RE: **RESPONSE TO 1<sup>ST</sup> REQUEST FOR ADDITIONAL INFORMATION CLARIFICATION**

**RE: RESPONSE TO FIRST REQUEST FOR ADDITIONAL INFORMATION CLARIFICATION  
J.E.D. SOLID WASTE MANAGEMENT FACILITY  
MODIFICATION OF GCCS SYSTEM – INTERMEDIATE MODIFICATION  
ADDITION OF HORIZONTAL GAS COLLECTORS (CELL 7 THROUGH 10)  
AND GCCS/LEACHATE SUMP CONNECTIONS  
MODIFICATION OF PERMIT NUMBER S049-0199726-012  
PERMIT APPLICATION NO. S049-199726-015**

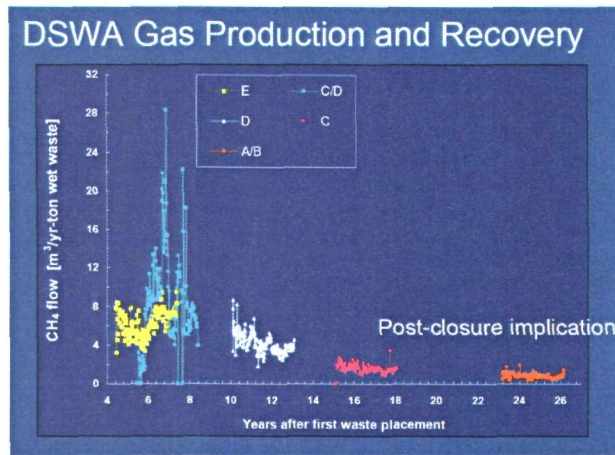
**Comment 9** *Exhibit 2. Engineering Design Narrative, Appendix A. Design Calculations: Provide the source/reference used for the following constants used in your design calculations:  $P_{landfill}$ , Intrinsic Waste Permeability ( $K_i$ ), Gas Generation Rate (GGR), Waste Density, and Dynamic Viscosity.*

**Response 9** **The landfill pressure is based on Golder's experience for landfill sites under steady state conditions and represents the generation of landfill gas under nominal cover conditions. We have measured this pressure in passive landfill vents. The intrinsic waste permeability was estimated using data from a paper entitled "Gas permeability and tortuosity for packed layers of processed municipal solid waste and incinerator residue", by Kallel et. al published in Waste Management and Research in 2004.**

**The graph on the following page is from a presentation from Dr. Mort Barlaz regarding the gas production and recovery at a Delaware landfill. During the first 8 to 10 years after waste placement, the gas generation rate tends to range between 4 and 8 cubic meters per year per ton of wet waste and decreases thereafter. Using a value of 6 cubic meters per year per ton of wet waste yields 0.1 cubic feet of gas per year per pound of waste as used in the calculations. The graph below illustrates different cells in the landfill that Dr. Barlaz analyzed for his**

presentation. Please note that a value of 6 cubic meters per year per ton of wet waste was used as a conservative estimate for the average of the values from this graph.

**ATTACHMENT 1**

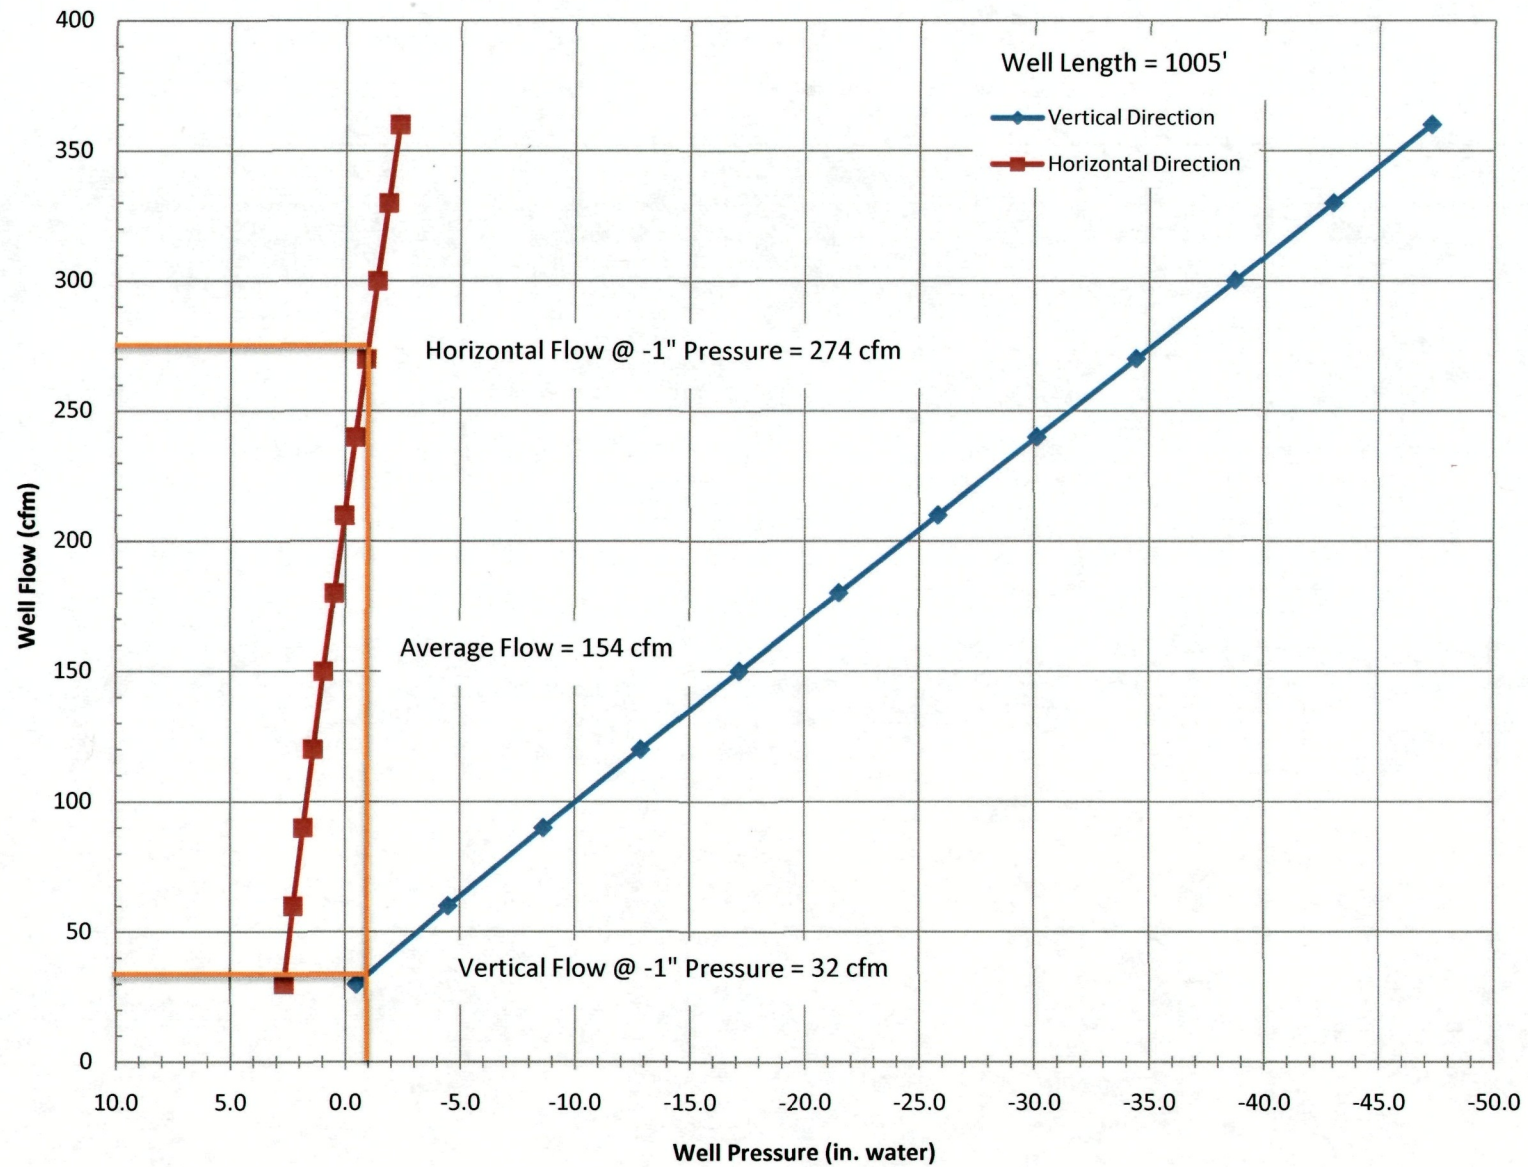
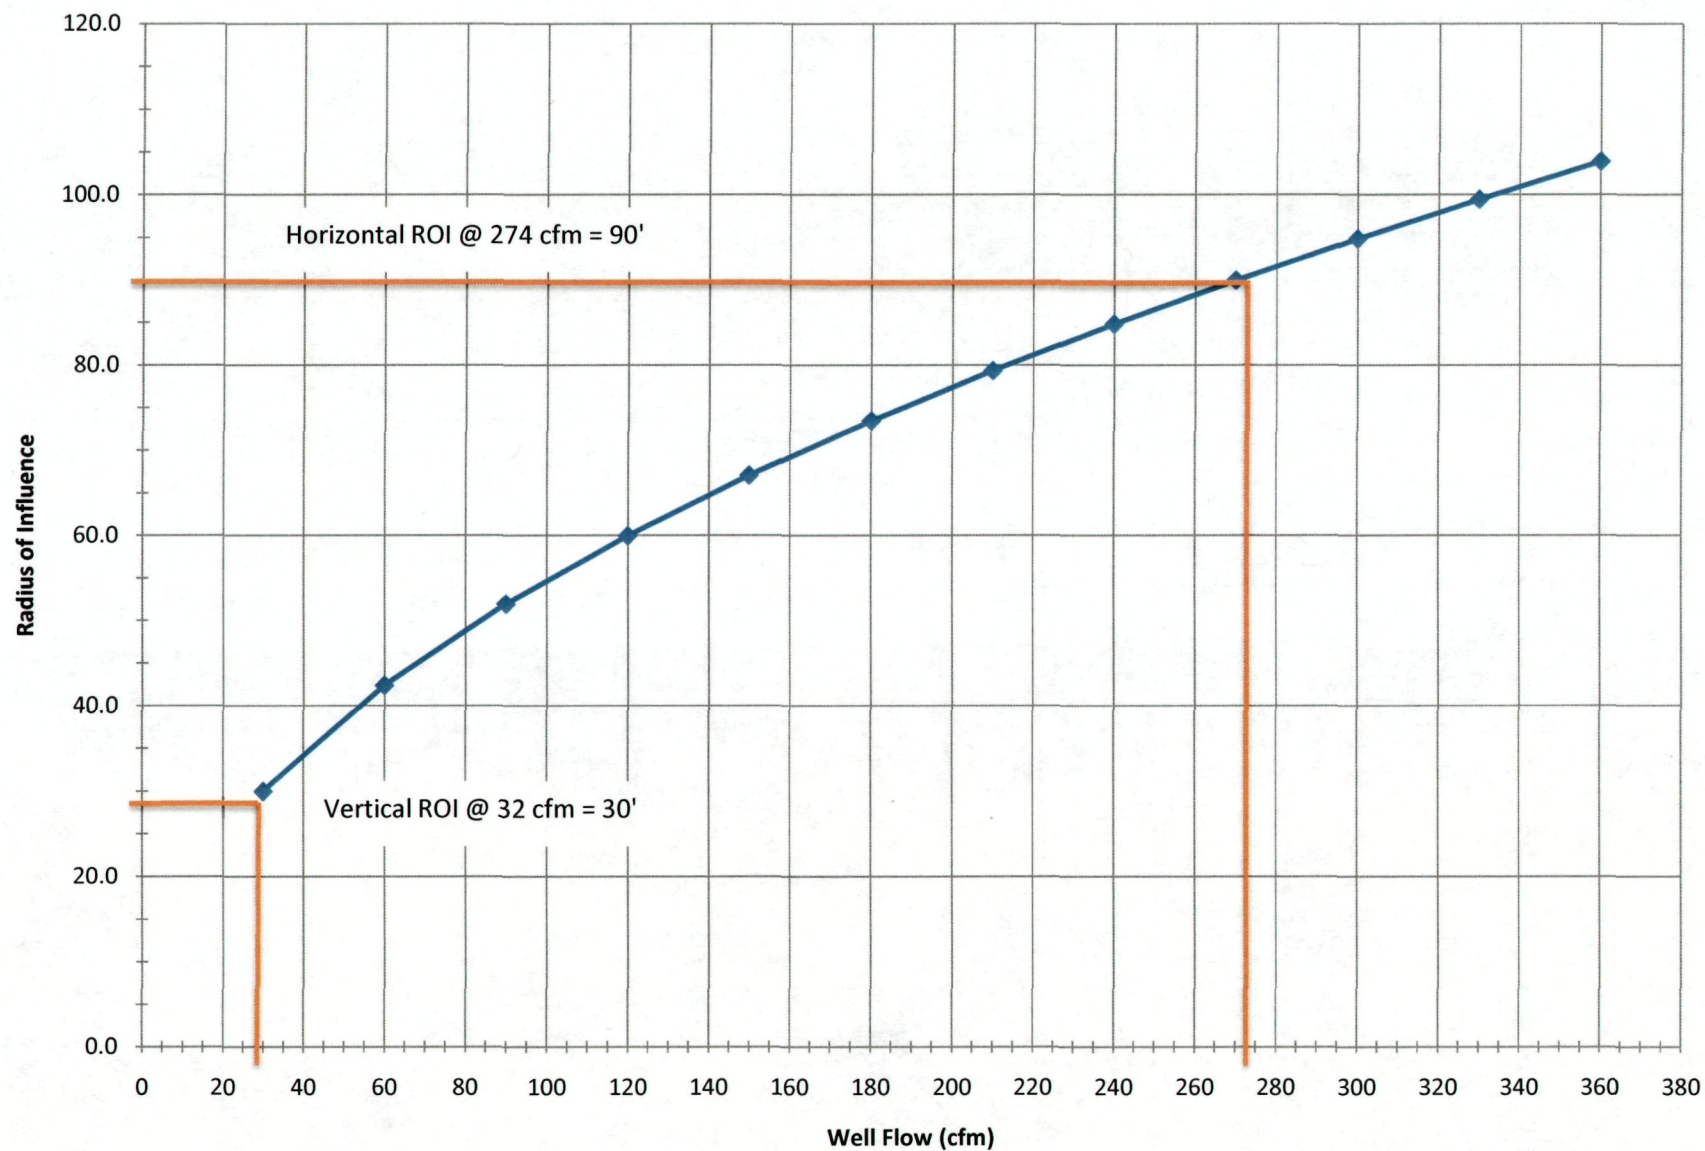
Comment 10 Exhibit 2, Engineering Design Narrative, Appendix A, Design Calculations, LFG Extraction Well Horizontal Design and Spacing Calculations: The longest perforated pipe length is Well HGC-8; it is approximately 1005 feet long. Provide the basis for using 400, 500, and 600 feet H values in the calculations for well pressure and well ROI. Provide the revised calculations using H value of 1005 feet or explain why this H value of 1005 was not used in the design calculations related to well pressure and well ROI.

Response 10 The calculation presented uses the H value (for vertical wells total well depth) to estimate the associated radius of influence. In converting that calculation to estimate the zone of influence for HGCs, some compromises were required. The H value still represents total depth, but we have conservatively estimated it to be high (greater than the total waste thickness at the facility). We looked at three separate scenarios to illustrate variations in the zone of influence associated with various waste depths and then extrapolated this data to estimate ROI's for different pipe lengths. Note that these devices are temporary in nature, due to this the spacing (ROI) is not deemed critical. A revised calculation is provided for a well length of 1,005 feet. This calculation indicates an average flow of about 154 cfm with corresponding radii of influence values of 30 feet in the vertical direction and 90 feet in the horizontal direction at very low pressures (1-inch of water). Although these values are less than the spacing included with the design, the effects on the performance of the horizontal collection system are expected to be minimal for the following reasons:

- The design pressure value is very low, which is considered conservative and represents conditions towards the remote end of the well.
- The longest horizontal wells are deep within the landfill and any gas not intercepted by these wells will likely be intercepted by horizontal or vertical wells located at higher elevations than these wells.
